TRANS/WP.29/1006
19 April 2004

World Forum for Harmonization of Vehicle Regulations (WP.29)

DRAFT SUPPLEMENT 3 TO THE 01 SERIES OF AMENDMENTS TO
REGULATION No. 67

(Equipment for liquefied petroleum gas)

Figure 3: connecting area of the light vehicle Euro filling unit"

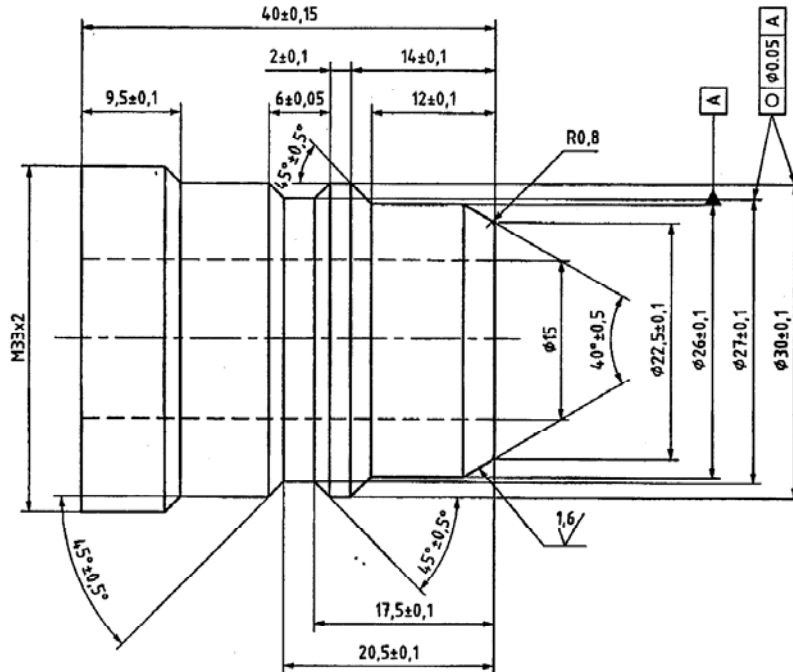
Insert a new Figure 3, to read:

"6.15.10.6. Specific provisions regarding the light vehicle Euro filling unit (Annex 9 – Figure 3):

6.15.10.6.1. The dead volume between the front sealing surface and the front of the non-return valve shall not exceed 0.1 cm³;

6.15.10.6.2. The flow through the connector at a pressure difference of 300 kPa shall be at least 60 litres/min, if tested with water.
